CITY OF CARMEL-BY-THE-SEA PLANNING COMMISSION

SPECIAL MEETING Tuesday, February 13, 2024

CITY OF CARMEL-BY-THE-SEA PLANNING COMMISSION Staff Report

EXISTING SITE PLAN

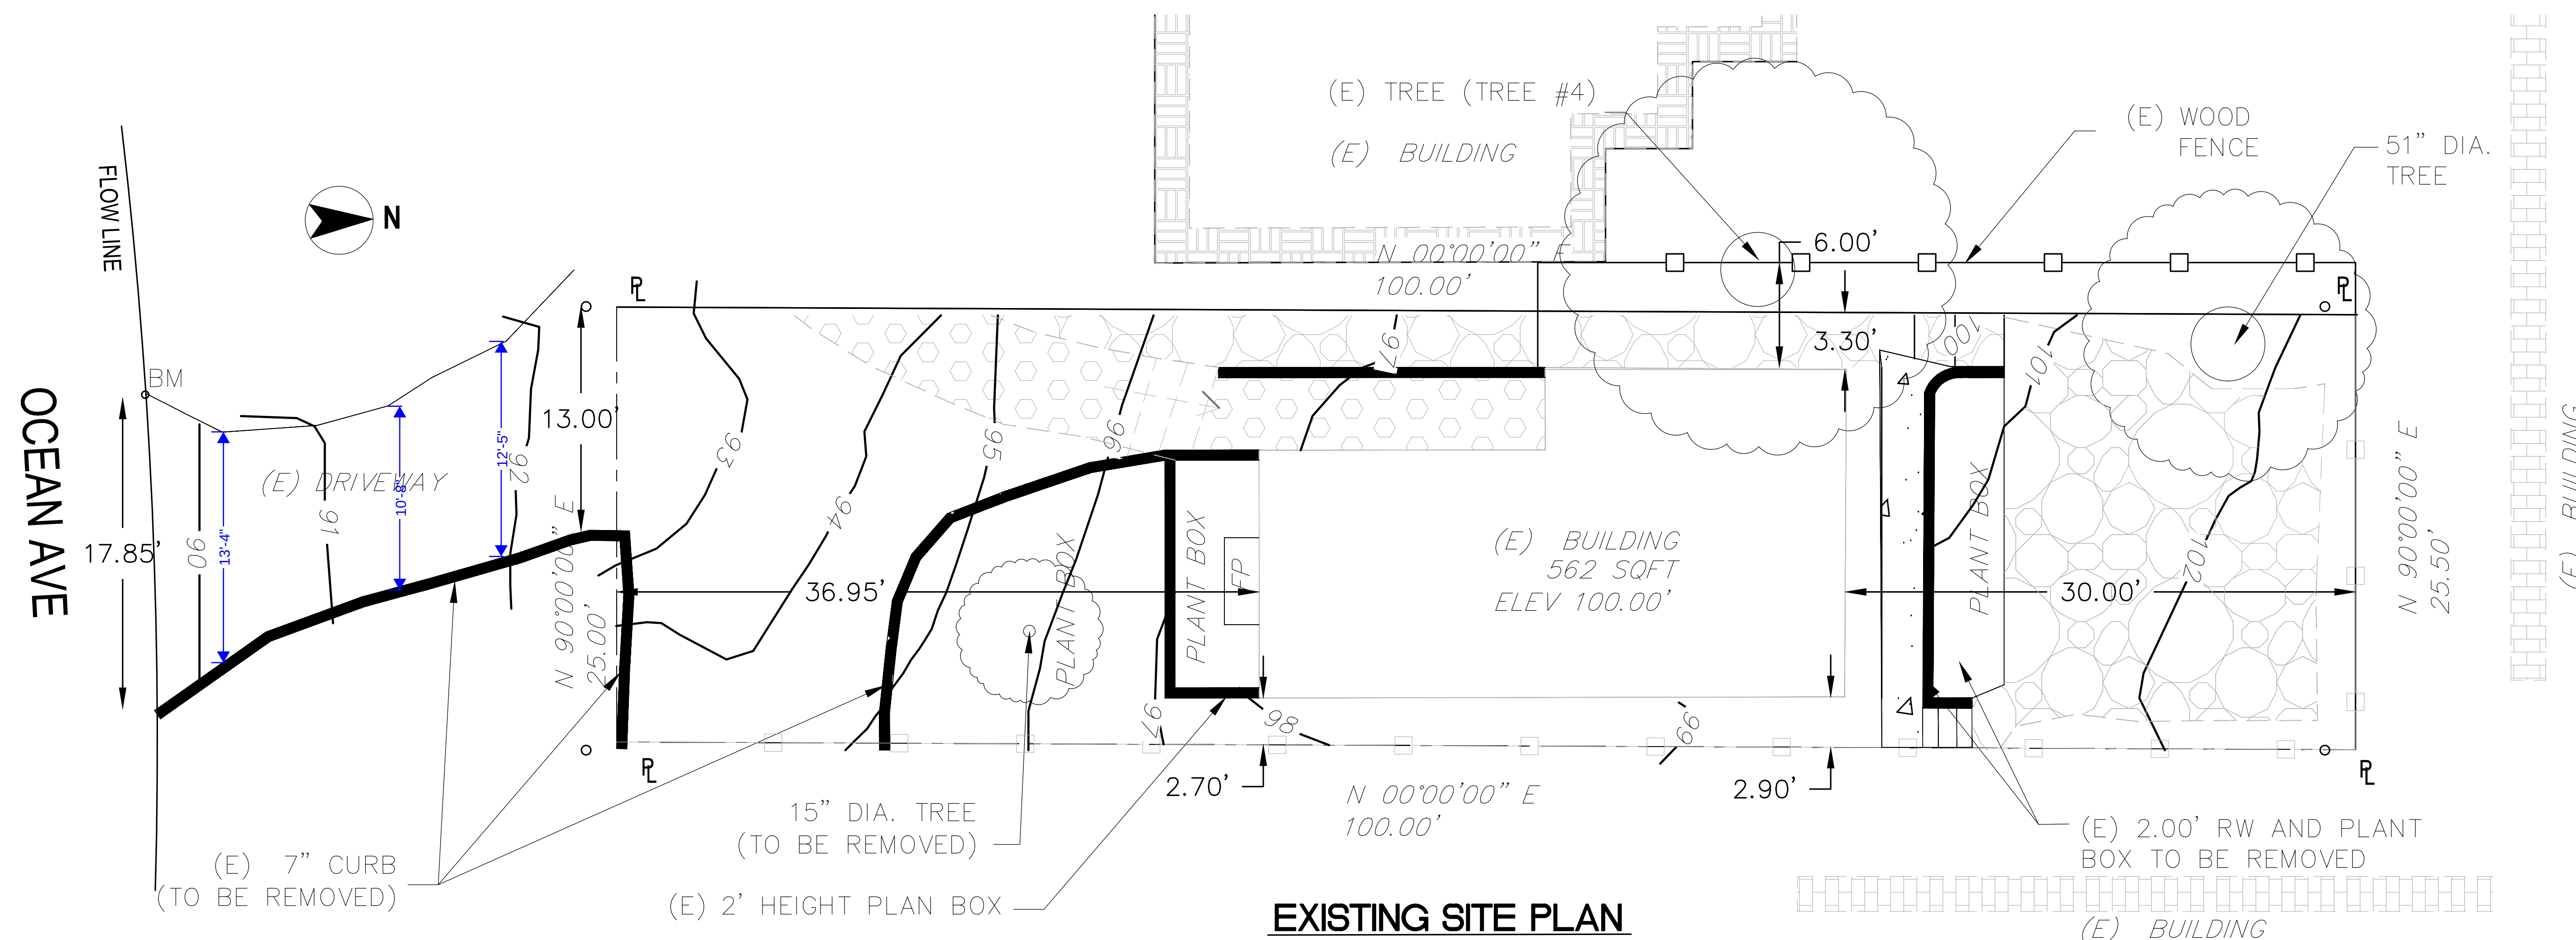
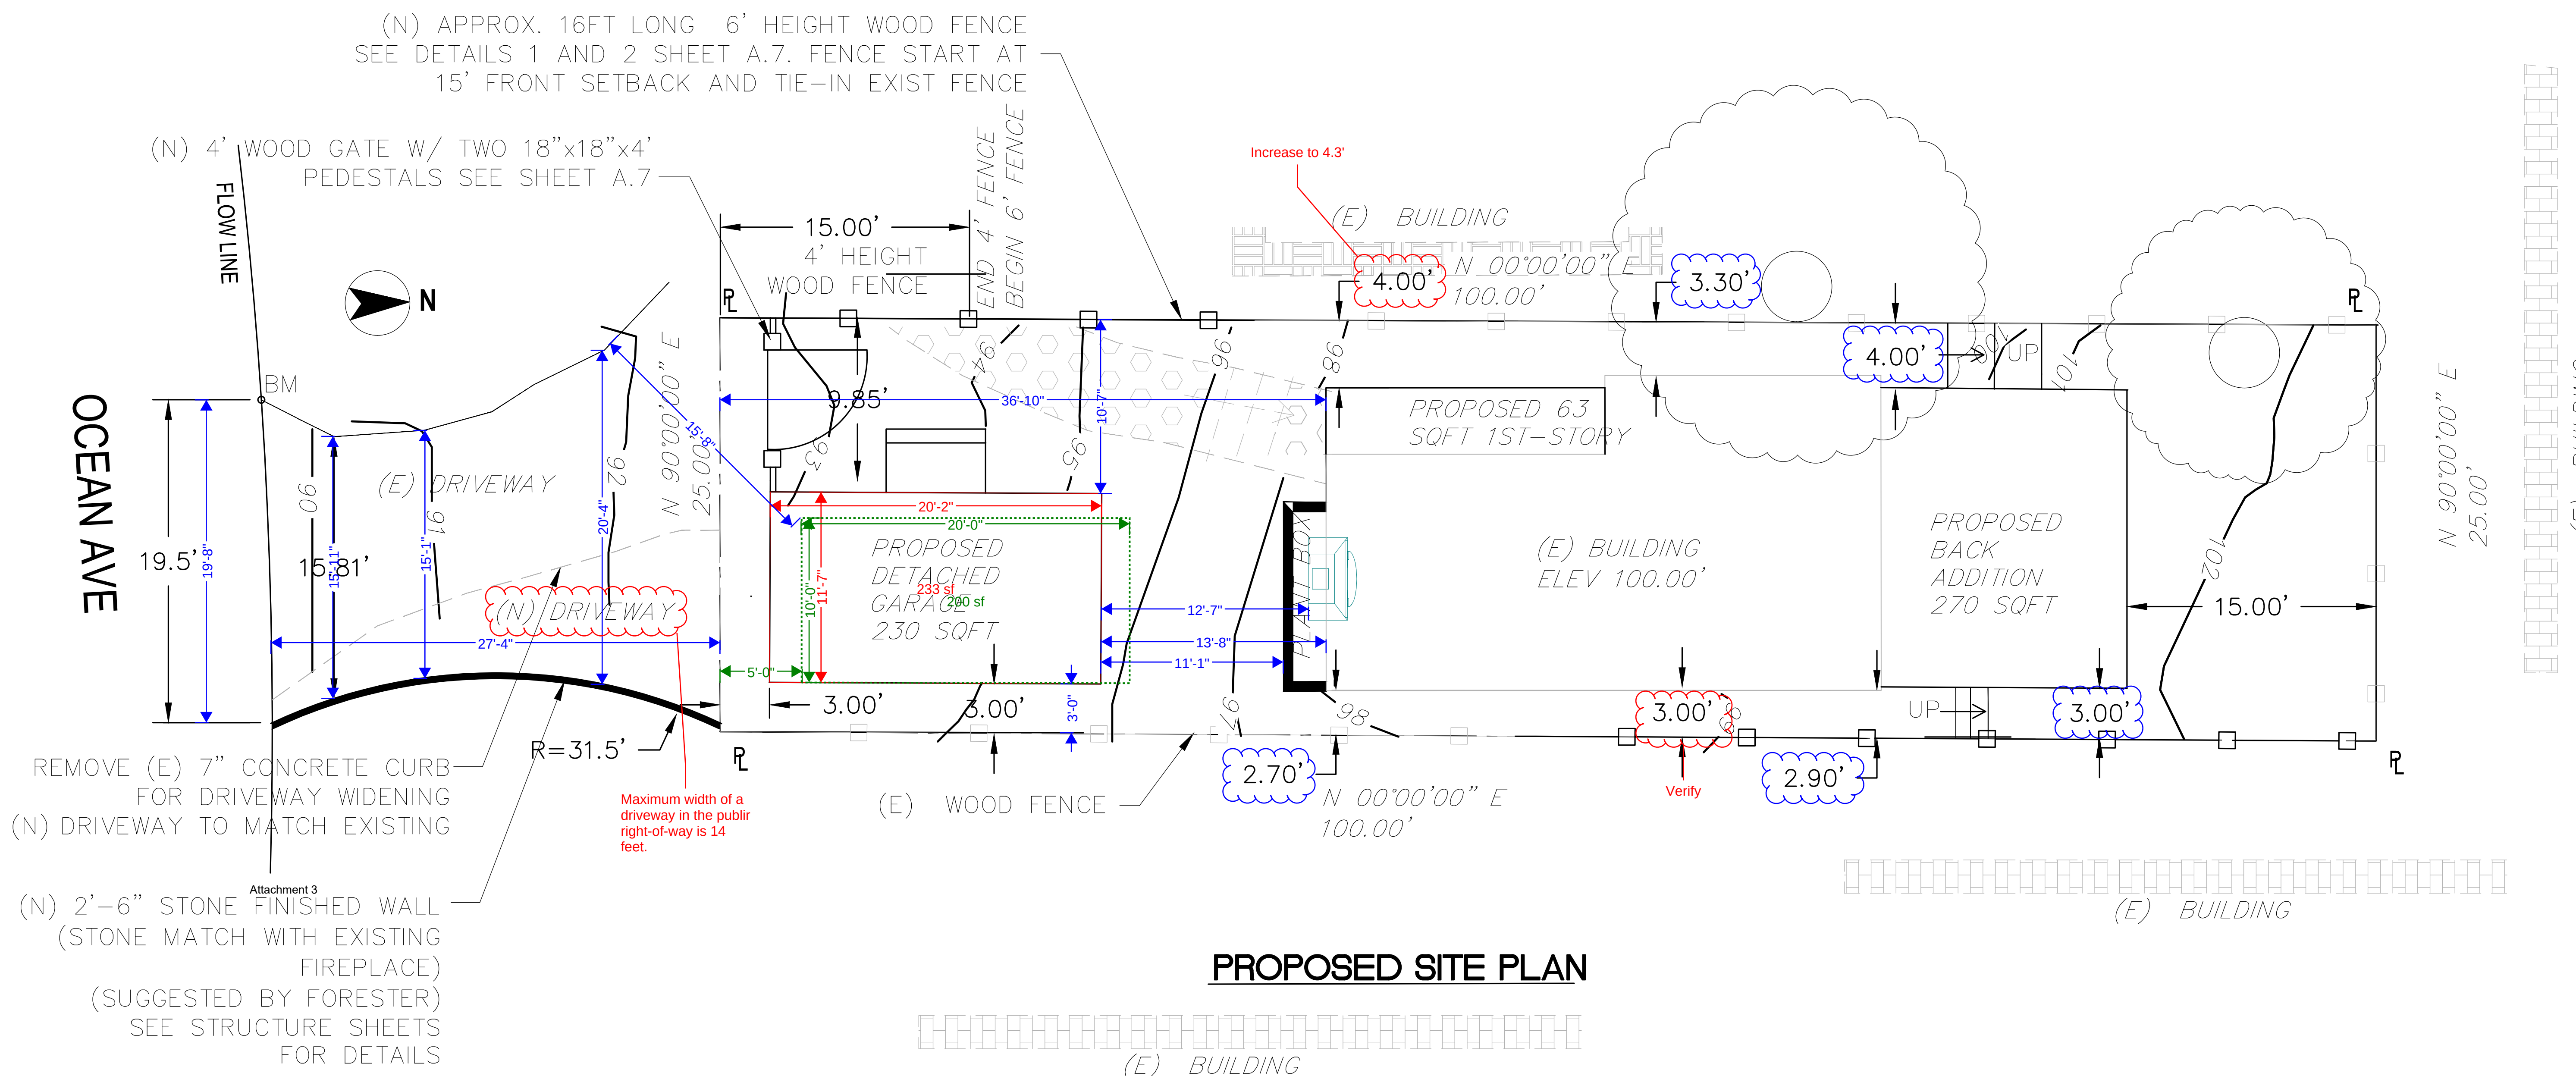
On Sheet 1, illustrating the Existing Site Plan and the Proposed Site Plan (please see Appendix 1), the east setbacks closest to my property are indicated at 2.7' and 2.9' in the Existing Site Plan and seemingly at 3.0' (2.7', 2.9', and 3.0' all appear in a very confusing drawing) in the Proposed Site Plan. This drawing does not make sense in that the existing setback clearly ranges from 2.7' to 2.9'.

3. On page 5 of the plans, also called Sheet 1 and showing the existing and proposed fence lines and tree locations, the Existing and Proposed Site Plans are exactly same (the new garage and new extensions are not shown) and both show incorrect setbacks.
